Re: VARIANCE REQUEST  
TAYLOR PROPERTY  
1828 MILVALE ROAD  
ANNAPOLIS, MD 21409

**VARIANCE PLAN FOR THE TAYLOR PROPERTY**

## CONFIRMATION OF PRE-FILE MEETING

DATE OF COMMENTS 7/25/23

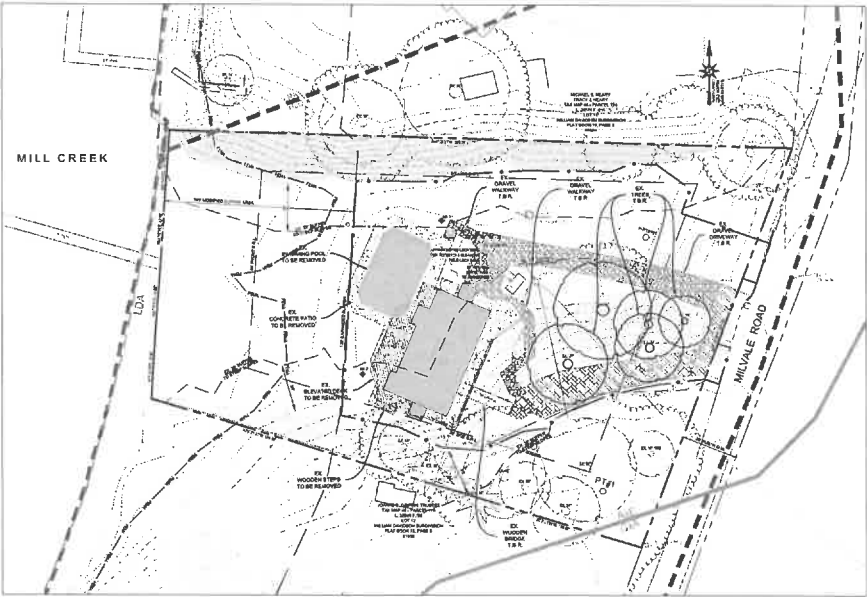
The site plan incorrectly shows a 25' buffer to the bottom of the steep slope. The buffer is only required to the top.

The disturbance to the steep slope buffer along the northern property line would require modification approval. This disturbance should be removed.

The LOD and grading along the southern property line should be reduced in order to protect the existing vegetation in that area.

1- In order to meet the intent of ESDv, the overflow and/or underdrain from MB-2 must discharge directly and not be connected to MB-1 as currently shown.

2- Soil borings are required to confirm the siting and suitability of the chosen facilities.

1. Add the height of the house (in feet) to the site plan in the location of the house.
2. You may submit your variance application via LUN once the site plan has been corrected.

In regards to the prefile comments dated 7-25-23, the following information is offered. The slope buffer to the northern property line is the bottom of the slope. This was shown strictly for the Health Department, as their buffers for septic systems are both to the top and bottom of the slope. This buffer and all bottom of slope buffers have been removed from the variance plan. The LOD and grading along the southern property line has been reduced in order to protect the existing vegetation in that area. The underdrain discharge pipes from MB-1 and MB-2 have been disconnected in order to meet the intent of the ESDv. Soil borings have been performed at both of the micro-bioretenion facilities and the soil data analysis has been added to the plans. The height of the proposed house has been added to the plan.
